**Project: Renovate Building 28 First Floor East RRTP**  
**Revision Set: 2 (Prebid Addendum)**

VA Project #: 656-19-306  
Anderson Project # 15451

Date: July 23rd, 2021

**1 BASEMENT PIPING PLAN**  
1/8" = 1'-0"

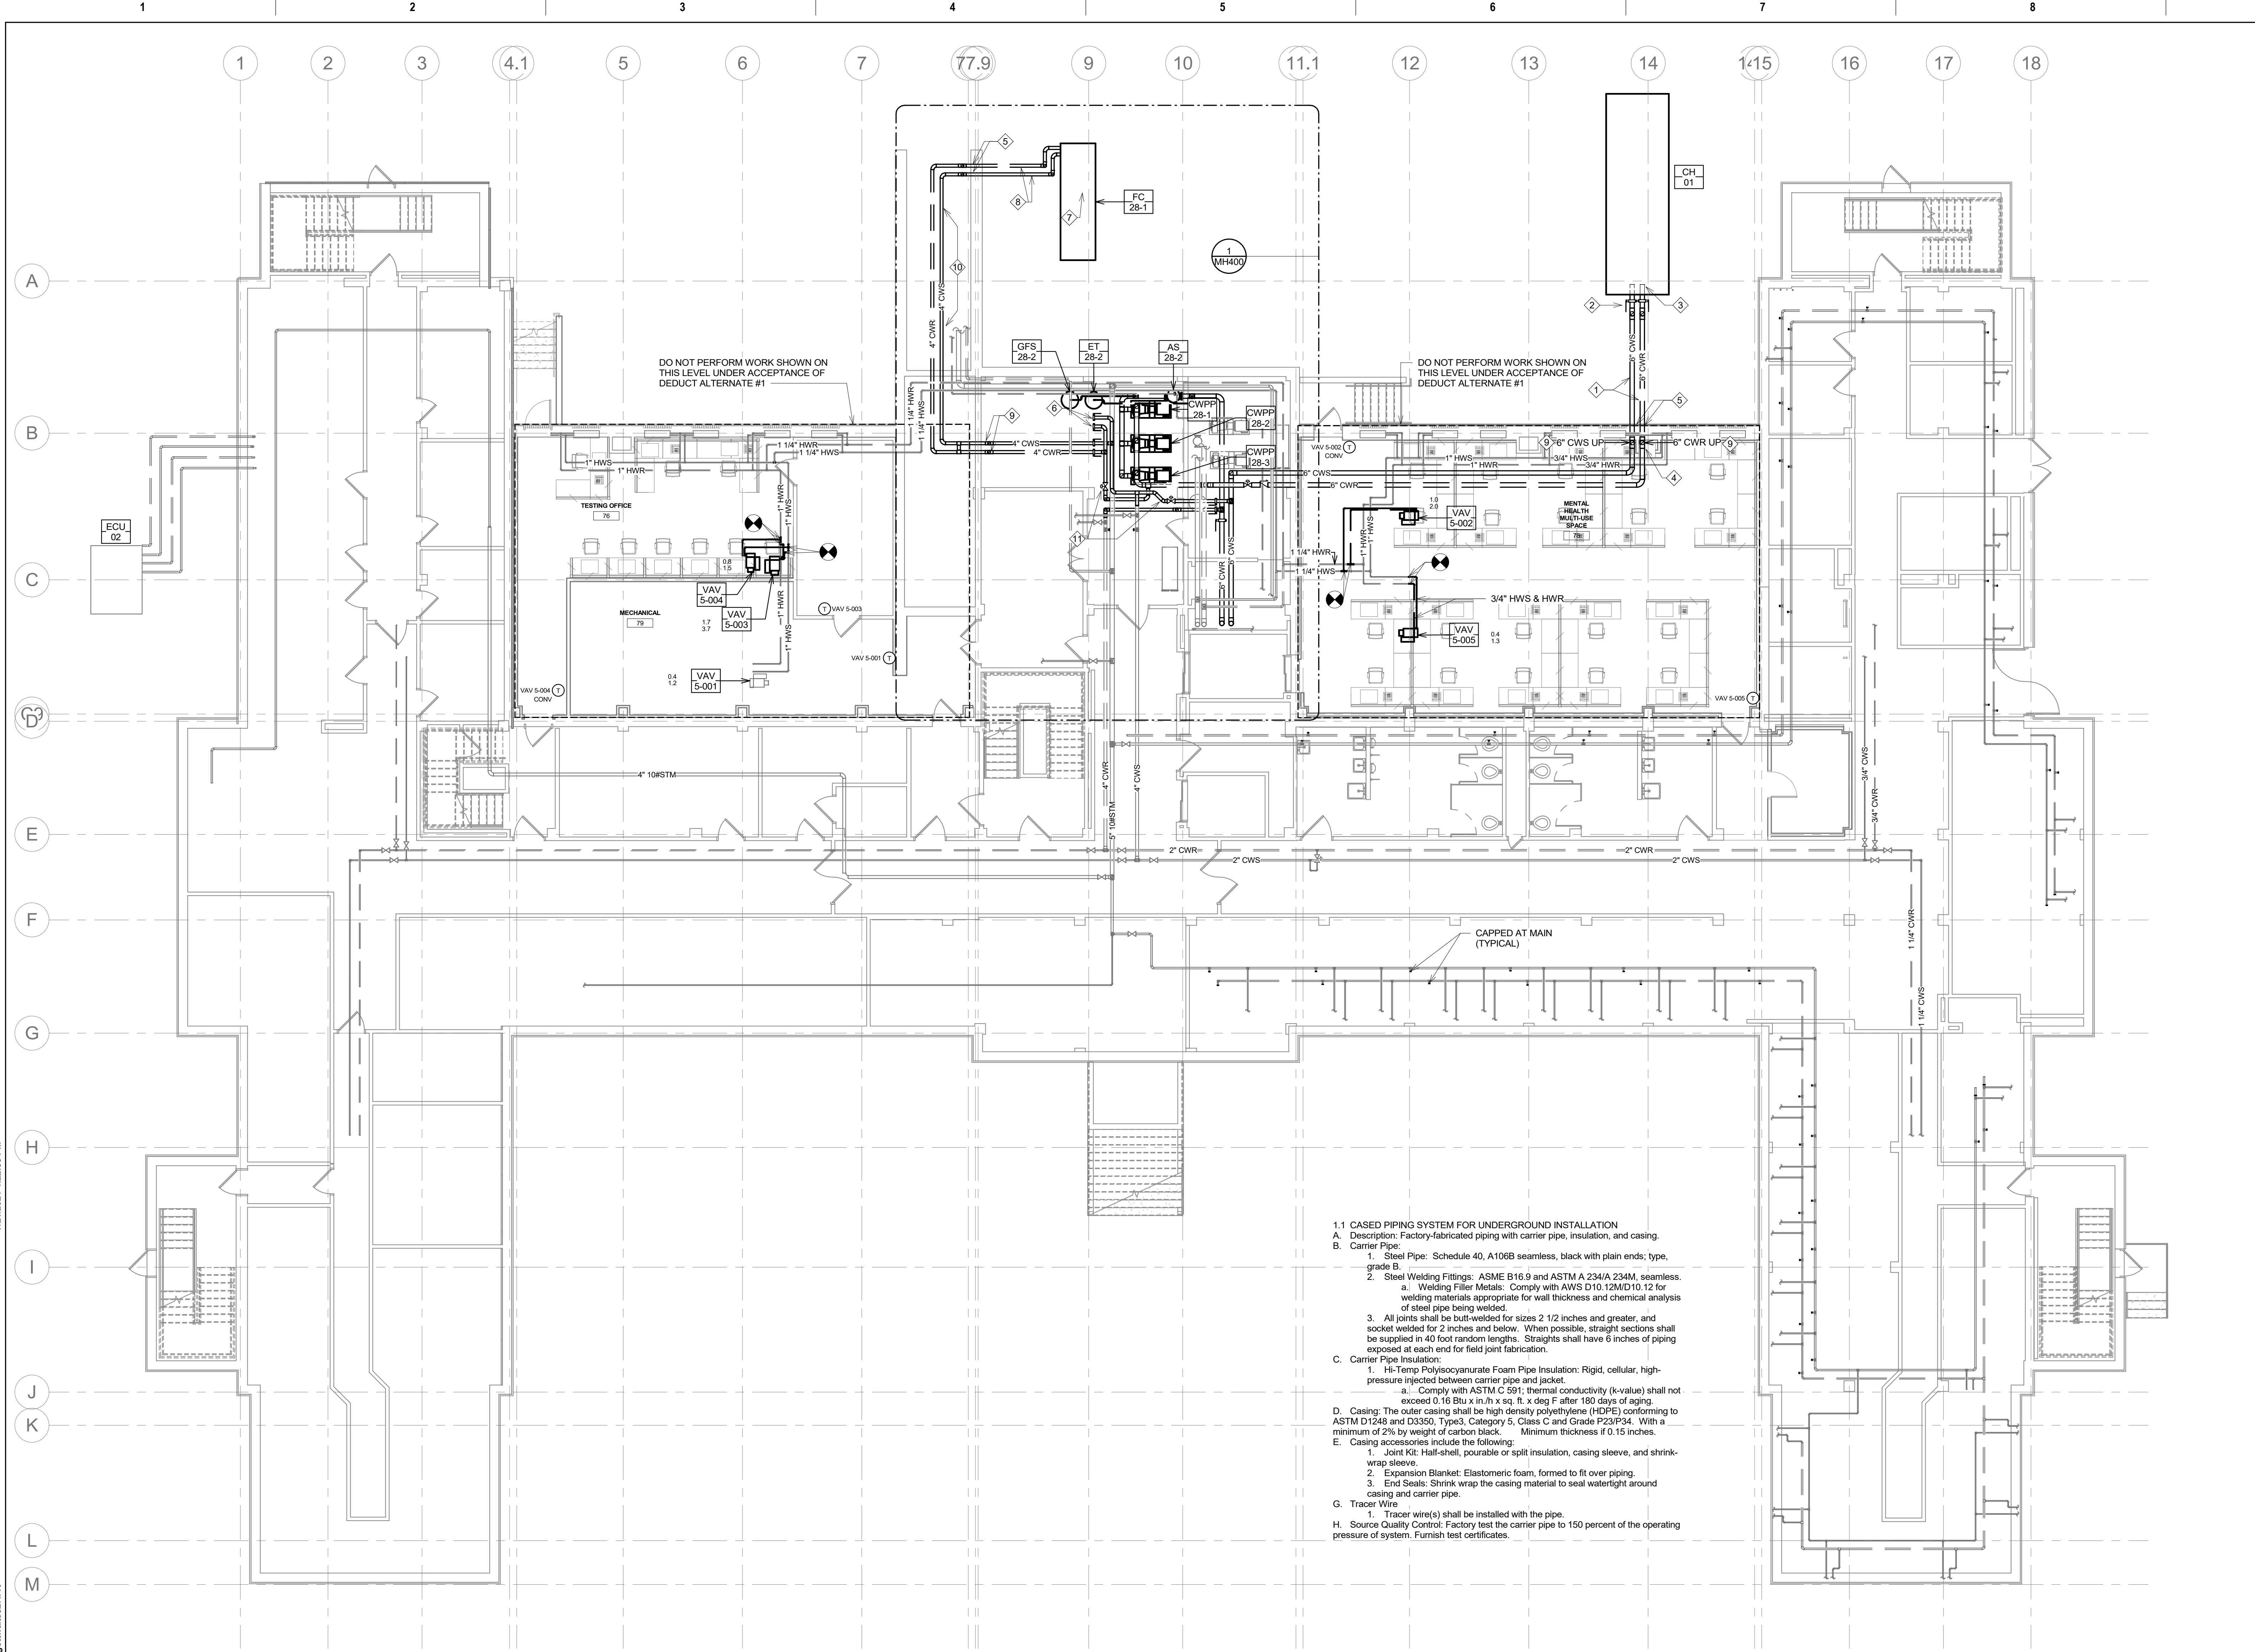
Sheet MP101, Basement Piping Plan: Clarified notes to indicate deduct alternate #4.

- 6. UNDER ACCEPTANCE OF DEDUCT ALTERNATE #4 THE INDICATED DRYCOOLER, AND ASSOCIATED PIPING AND CONTROLS, WILL NOT BE INSTALLED. INSTEAD EXISTING CONDENSING UNIT AND CHILLER WILL REMAIN. THE CHILLER SUPPLY/RETURN WATER CONNECTIONS INTO NEW ISOLATION VALVES INDICATED. COORDINATE ALL PIPING INSTALLATION TO ALLOW FOR MINIMAL OUTAGE TO THIS SYSTEM THAT PROVIDES YEAR-ROUND COOLING TO LOWER LEVEL.

- 7. PROVIDE DRYCOOLER ON EXISTING CONCRETE PAD. CONTRACTOR TO VERIFY PAD SIZE WITH SHOP DRAWINGS AND EXTEND, OR MODIFY, CONCRETE PAD AS REQUIRED FOR DIMENSIONS OF DRYCOOLER FURNISHED WITHIN THEIR CONTRACT. DO NOT PROVIDE UNDER ACCEPTANCE OF DEDUCT ALTERNATE #4.

1 FIRST FLOOR PIPING PLAN  
1/8" = 1'-0"

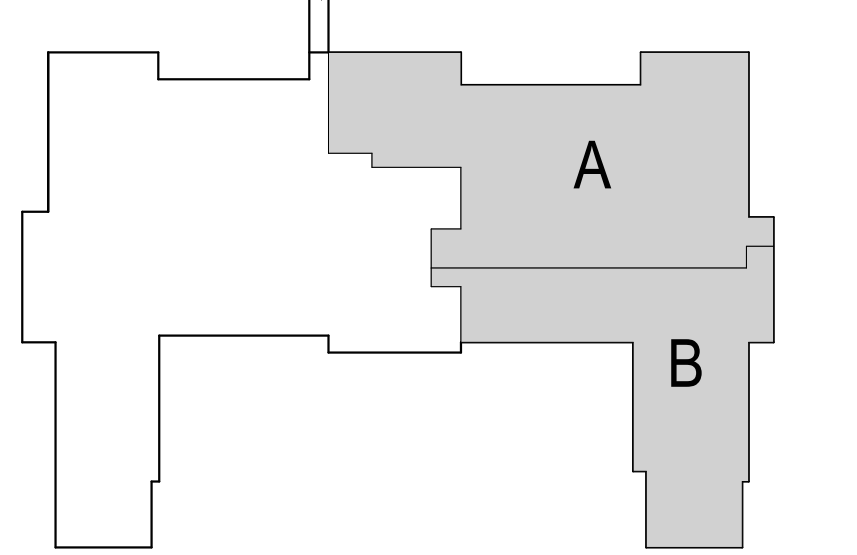
Sheet MP111, First Floor Piping Plan: Added 3 temperature monitors for refrigerators.

- 15 PROVIDE A TEMPERATURE MONITOR WITHIN EACH REFRIGERATOR STORING PATIENT DRUGS AND/OR FOOD. THREE (3) MONITORS SHALL BE INCLUDED WITHIN THIS PROJECT INSTALLED IN KITCHENETTE AREA, MEDS ROOM, AND SPD CLOSET. COORDINATE EXACT MODEL TO INCORPORATE INTO ST. CLOUD VA WIRELESS DATA FOR TRENDS LOGGING AND REMOTE ALARMS TO BUILDING AUTOMATION SYSTEM.

1 FIRST POWER FLOOR PLAN  
1/8" = 1'-0"

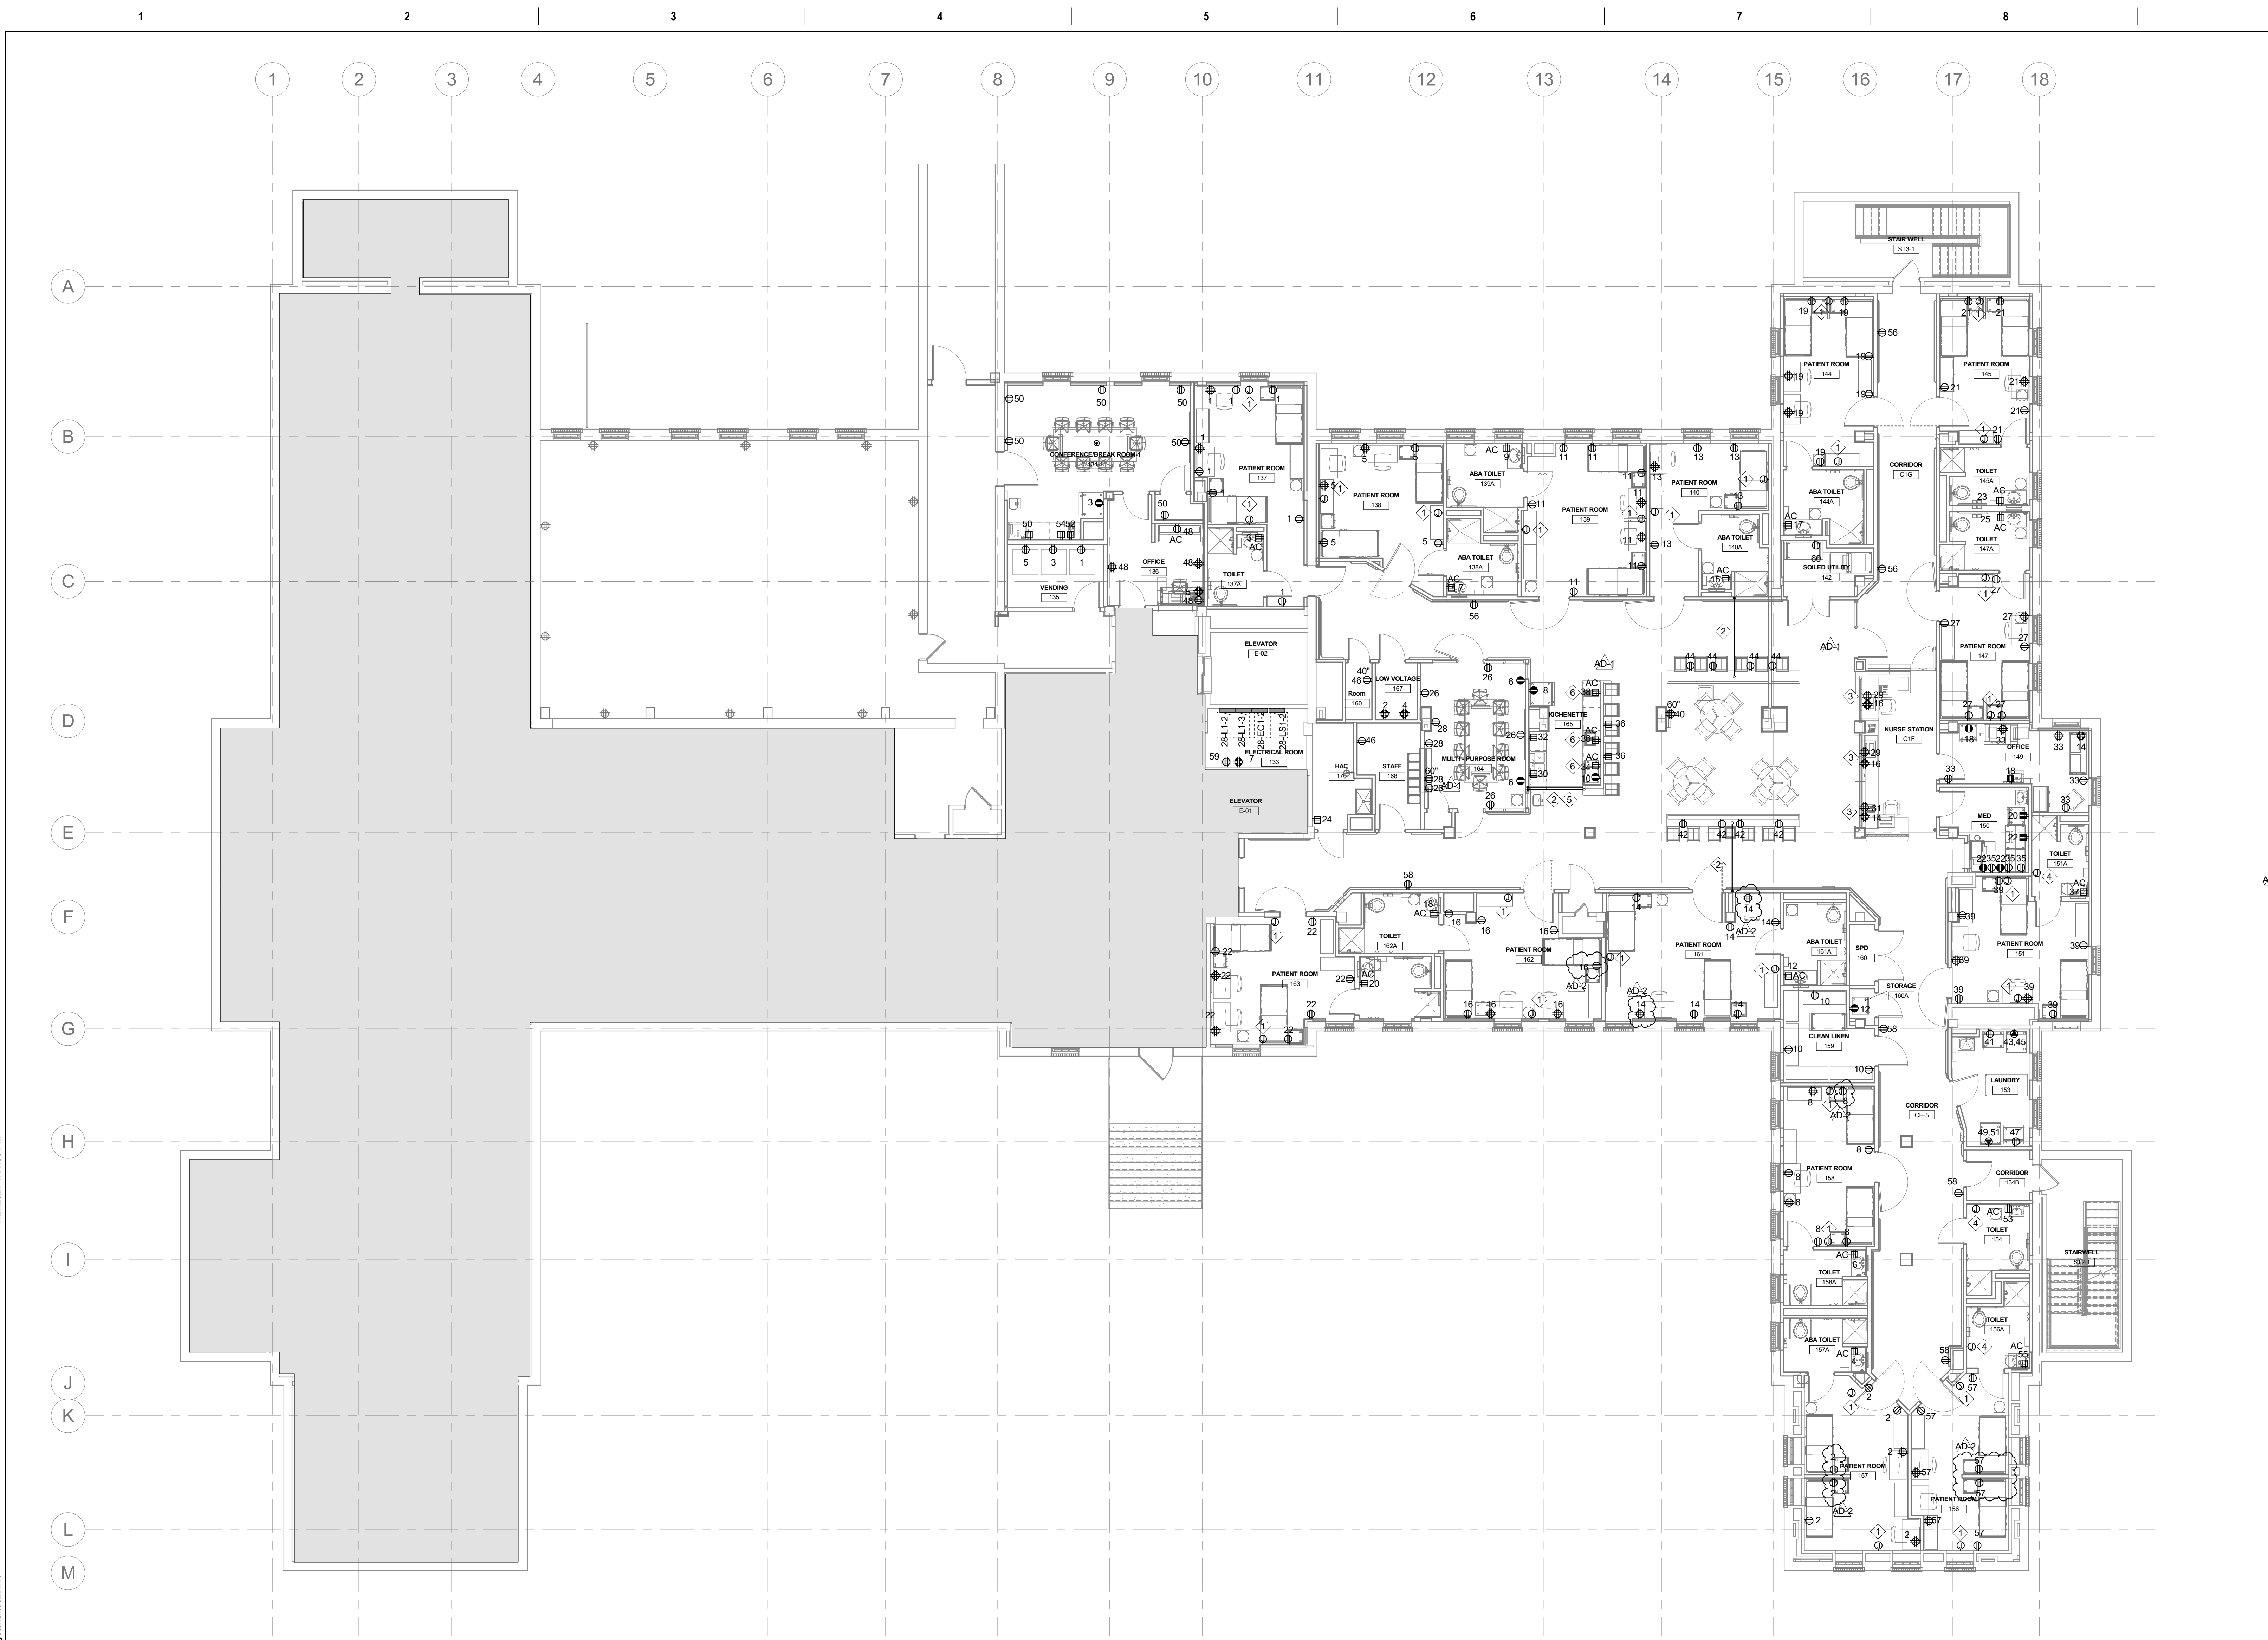
Sheet EP111, First Power Floor Plan: Revised device layout in patient rooms.
